Anonymous Referee #2

Received and published: 27 December 2019

Fig 1. Results of the additional tests.

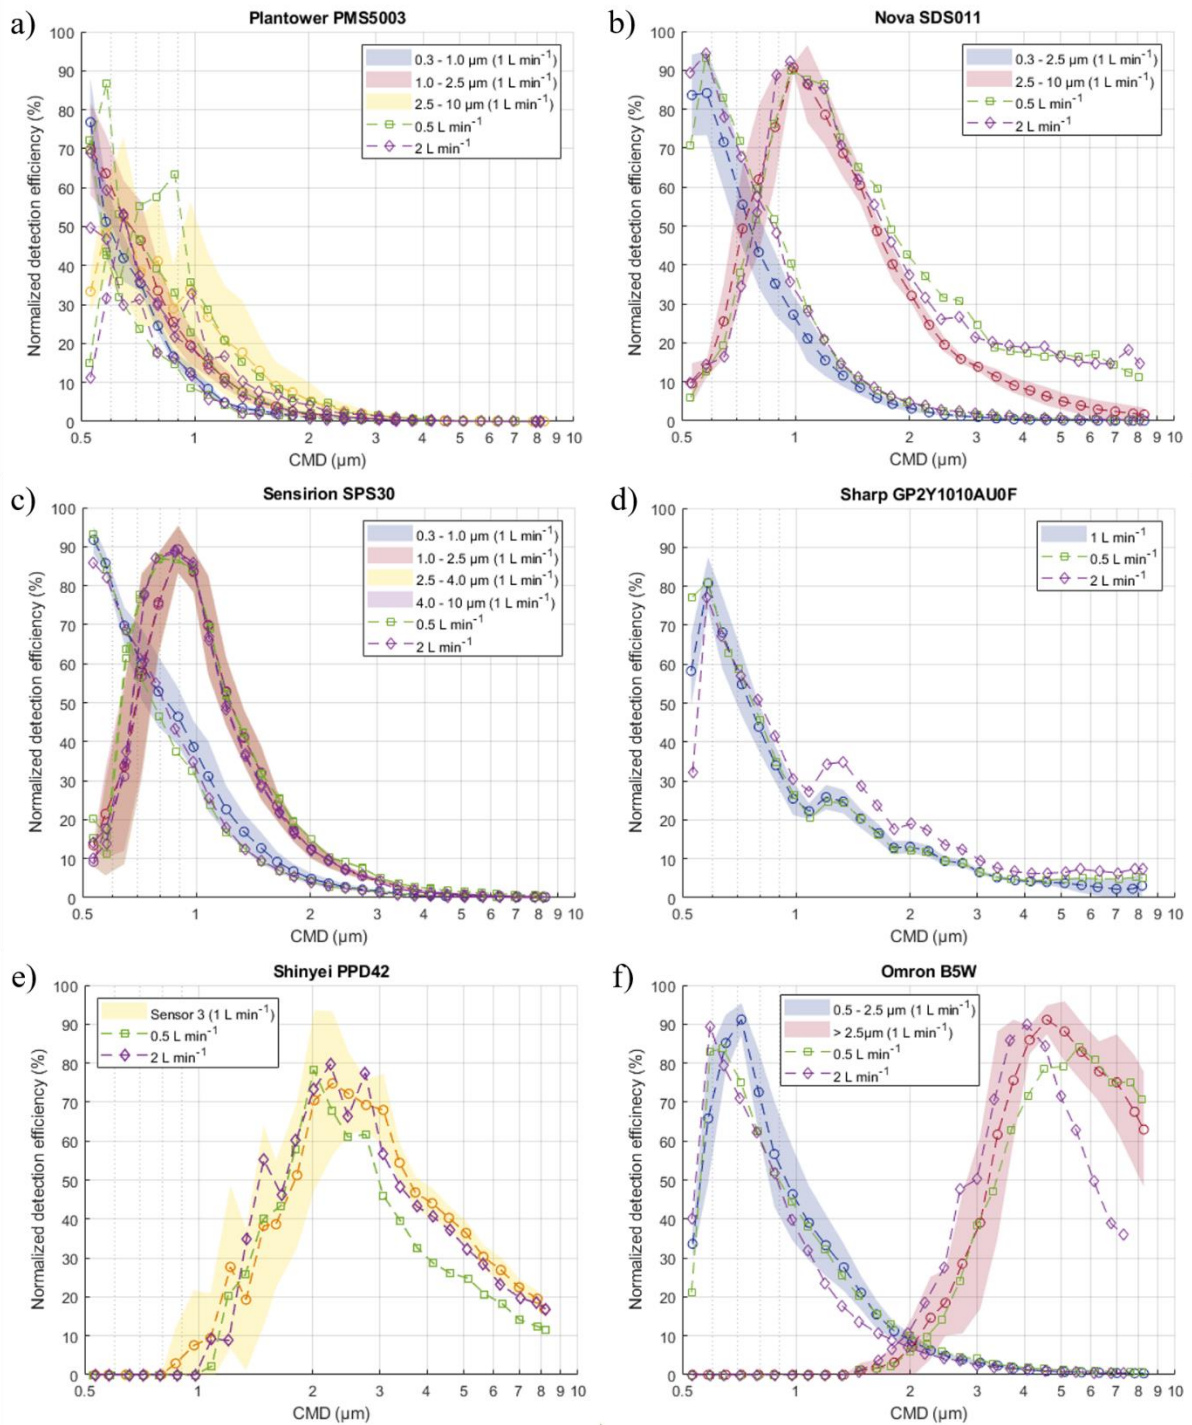
“I have some concerns regarding the effect of sample flowrate on the low-cost sensors. In the experimental setup, a pump draws the monodisperse particles into the sensor housing at a flow rate of 1 lpm. Figure S2 shows the sensor housing and placement of the low-cost sensors with the flow directed at the sensor inlet (mostly). The authors should consider whether this setup may be skewing their results. This is particularly important for sensors with fans that are designed to operate at a specific flowrate. It is possible that pushing a flowrate that differs from the design flow rate could alter the results. For example, the PMS sensor has a volumetric flowrate of approximately 0.1lpm (which is 10x lower than the volumetric flowrate into the sensor housing). Granted not all of the 1 lpm would flow into the sensor, but this is worth considering.”

There is no clear theoretical basis as to why a different flow rate would change the way the sensor discriminates different particle sizes. Assuming the sensors function as spectrometers (which the results of this study suggest they do, at least partly), the size discrimination of such devices is predicated on the analysis of pulse height caused by the scattering light of particle (Mie-theory). Change in the flow rate would change the frequency (i.e. number concentration) and duration of pulses but not their height. Whether the measured absolute concentrations were higher than expected is trivial as the data analysis of this study was based on normalized concentrations. Although possible, the effect of particle-size dependent sampling losses was originally estimated to be negligible, and as all the tested sensors seemed to exhibit similar size discrimination characteristics as what previous studies had shown, the effect of ancillary flow rate was not addressed in any way.

However, to ensure that the ancillary flow rate did not affect the results, additional tests were conducted with flow rates of 0.5 and 2 L min⁻¹. Instead of testing all the three sensor units of the six different sensor models, only a single unit (unit #3) for each sensor model was evaluated. The results (Fig. 1, attachment) indicate that different flow rates had no meaningful effect on the responses. The SDS011 shows slightly stronger response for particles larger than ~2 – 3 μm, but this is probably resulting from operator inconsistency (or randomness) because the change is similar for both 0.5 and 2 L min⁻¹ flow rates. The B5W sensor has weaker response for particle sizes larger than ~4 – 5 μm with 2 L min⁻¹ flow rate which suggests that the sampling losses may have increased. However, the response is similar for 0.5 and 1 L min⁻¹ flow rates (B5W was originally designed to be used with a heater resistor-induced flow which is most probably closer to 0.5 than 2 L min⁻¹). The difference in PPD42NS responses, which imply that the losses may have increased for smaller and not higher flow rates, is attributed to randomness.

While conducting the additional flow rate tests, the Sharp sensors were found to exhibit completely different characteristics to what was previously measured. The underlying reason for this is still unknown, but it is possible that a prototyping breadboard, which was used to make the required connections for the external resistor and capacitor, had loose connections which resulted in misleading bias measurements. Nevertheless, all the Sharp sensors were re-evaluated with the original 1 L min⁻¹ flow rate and the unit #3 was tested additionally with the 0.5 and 2 L min⁻¹ flow rates. The new valid detection range was measured to be < 0.8 μm which is no longer in an obvious conflict with the results of the previously mentioned study of Wang et al. (2015). Considering the additional tests, it appears that the different flow rates may influence the sensor response in smallest particle sizes (< 0.55 μm), but the responses with 0.5 and 1 L min⁻¹ flow rates are so similar that the stated valid detection range remains the same. Smaller flow rates are likely to better represent the original flow rate, which for the Sharp sensors, was based on plain diffusion.

Added to manuscript section 2.2.2 “Sampling configuration”: “Although there is no clear theoretical basis as to why a different flow rate would affect the way the sensor discriminates different particle sizes (apart from the different particle size-specific sampling losses), additional tests were conducted with flow rates of 0.5 and 2 L min⁻¹ to ensure that this was indeed the case (see Supplemental Figure S2).”
